SITE CHARACTERIZATION REPORT - HYDROLOGIC CHARACTERIZATION

**HYDE PARK LANDFILL SITE
TOWN OF NIAGARA, NEW YORK**

APPENDIX C - RESPONSES TO AGENCY COMMENTS

**Prepared For:
Miller Springs Remediation Management, Inc.**

TRANSMISSIVITY DISTRIBUTION IN FZ-11
SITE CHARACTERIZATION REPORT
HYDE PARK LANDFILL SITE
Town of Niagara, New York

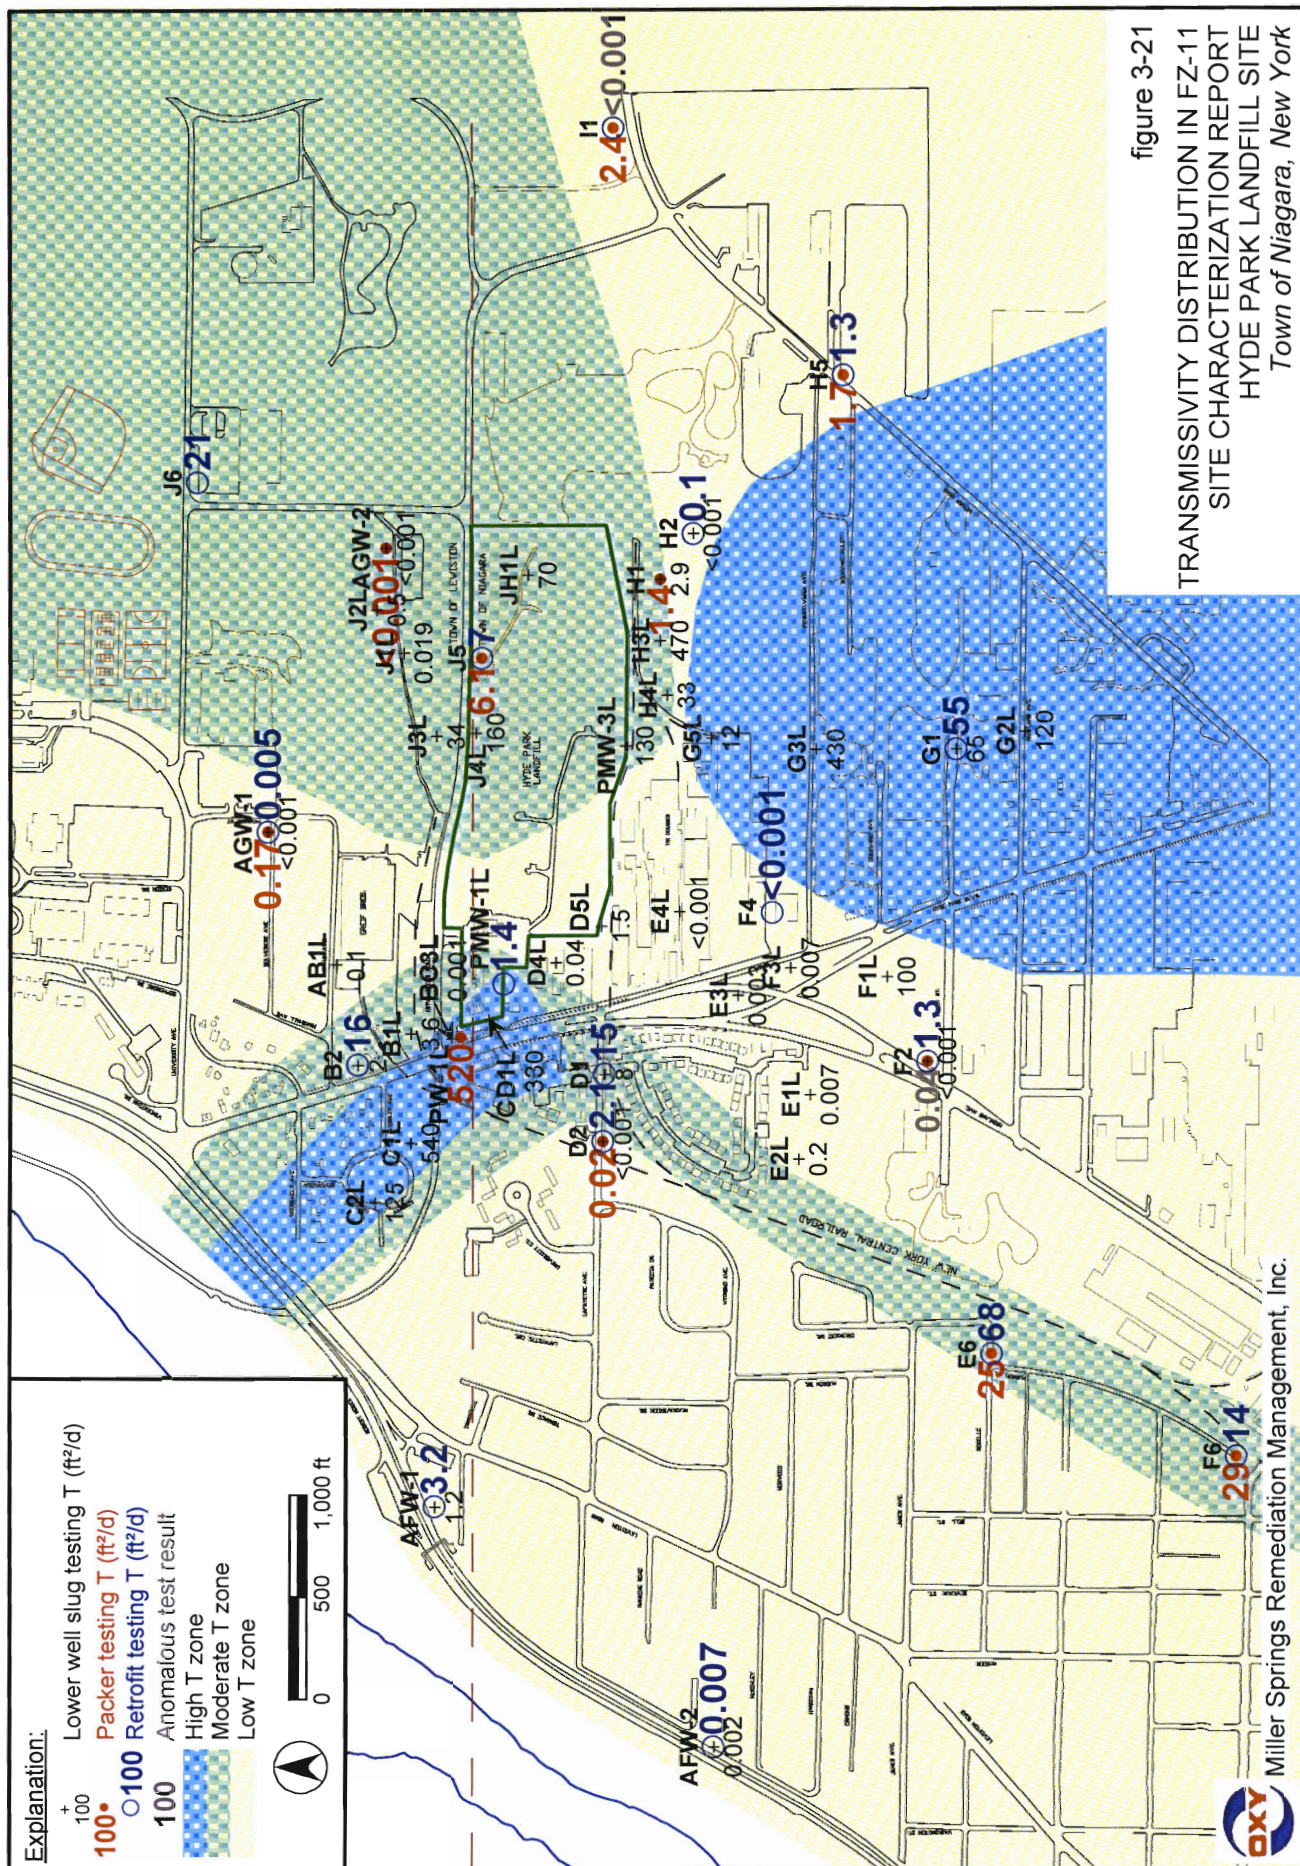
52. Figures 3-11 through 3-21. General comment: various transmissivity values are incorrect in comparison with the values presented in Appendix A. Please check values and edit.

The problem with Figure 3-12 was identified in our review of the final document. We apologize for the errors. All tables and figures have been checked. In some cases, the values indicated on the figures have been modified slightly to be absolutely consistent with the values provided in the tables. We are submitting a revised set of transmissivity maps, Figures 3-13 to 3-21, with these responses.

See the response to Comment S1.

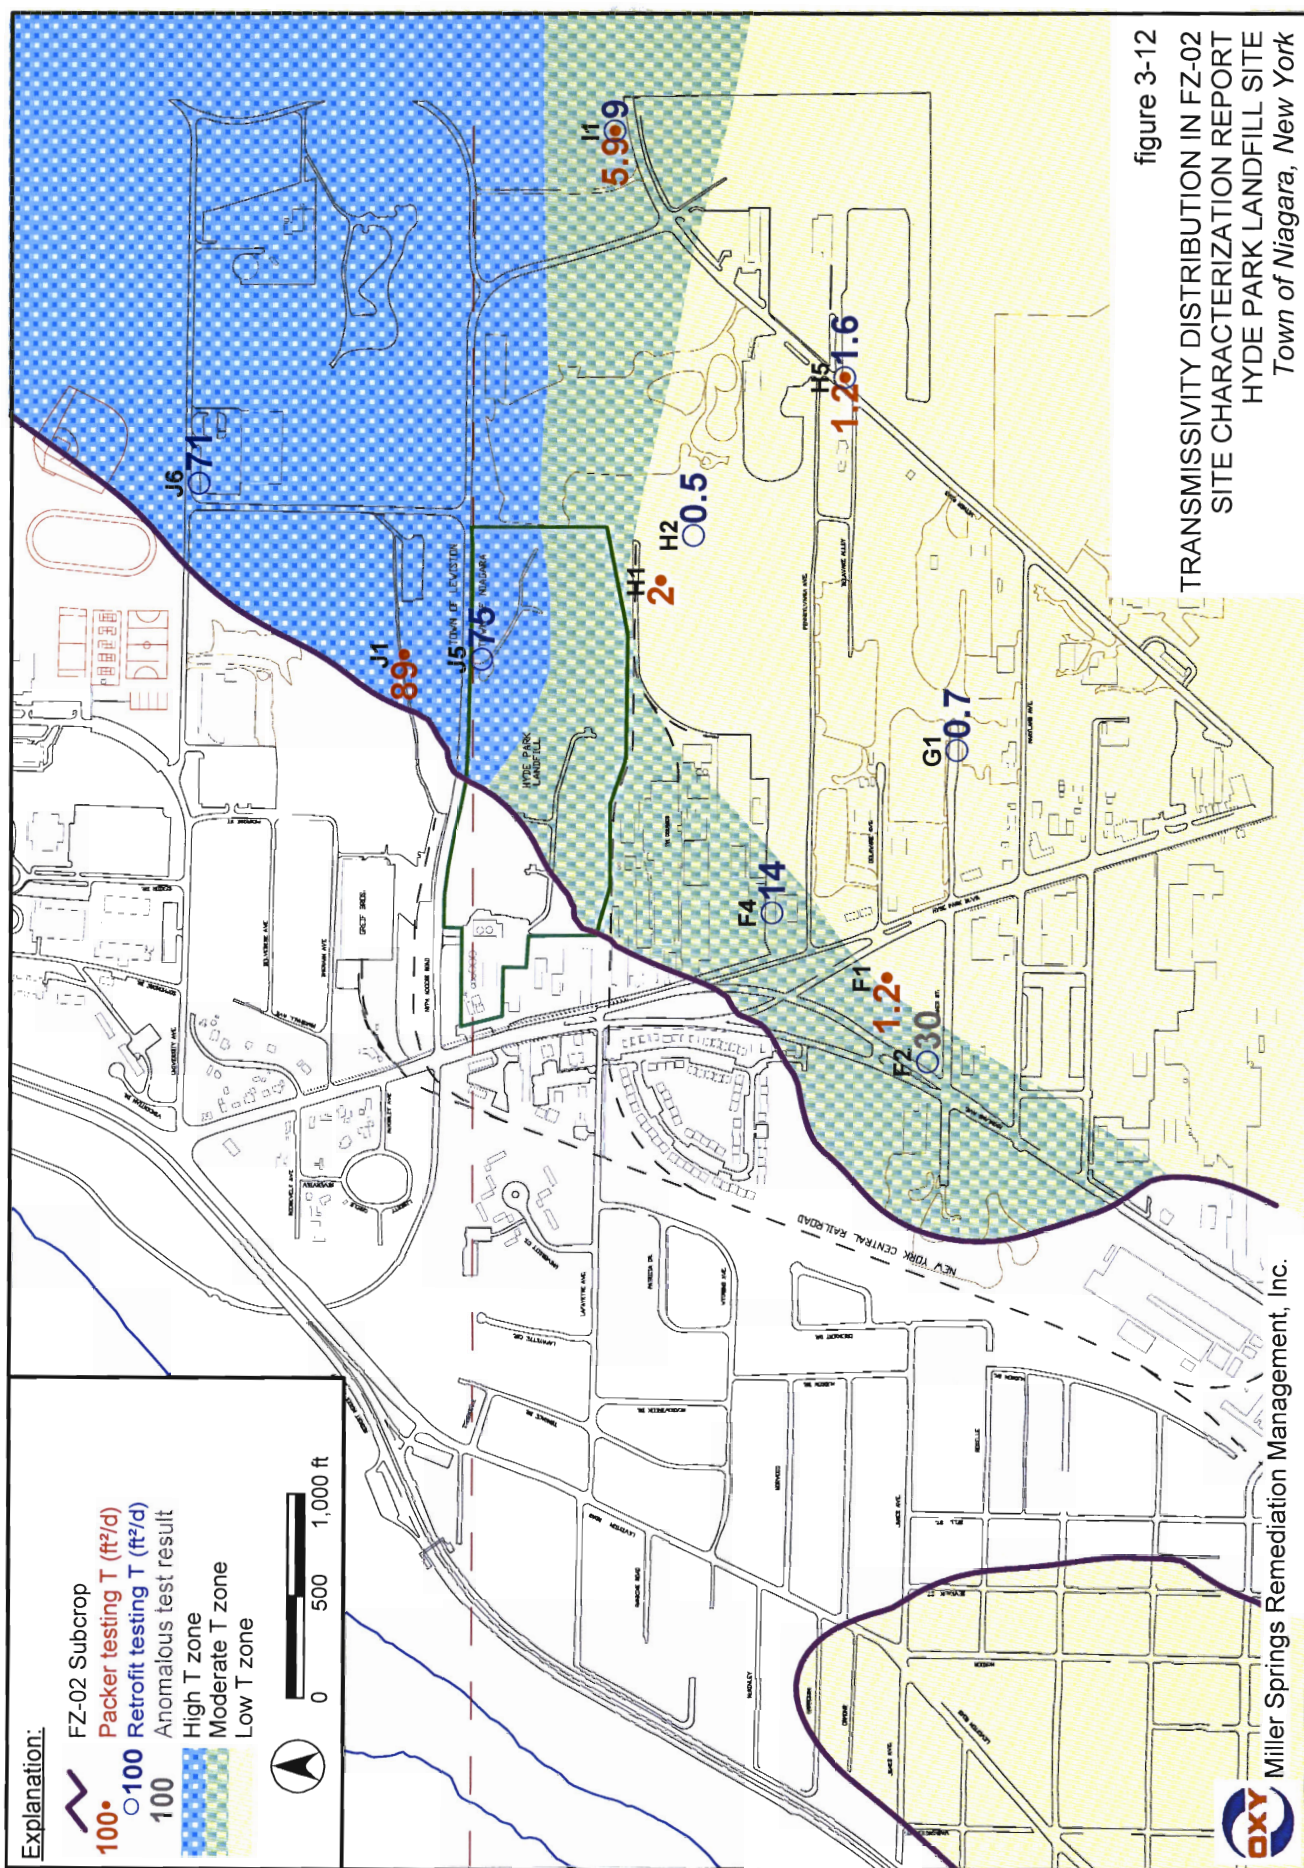
Several figures and tables do not present accurate data, and will require a more accurate quality control/quality assurance check. For example, in Figure 3-12, every transmissivity value that is presented is incorrect. All presented data and values need to be reviewed prior to the next submission.

51. Figure 3-12. Incorrect values for FZ-02 are presented in this figure. Please edit and re-submit.

We apologize for the mistakes on this figure. A complete set of transmissivity maps is attached with these responses. Numerous small changes to the figures have been made to ensure that the values shown in the figures are completely consistent with results presented elsewhere in the report.
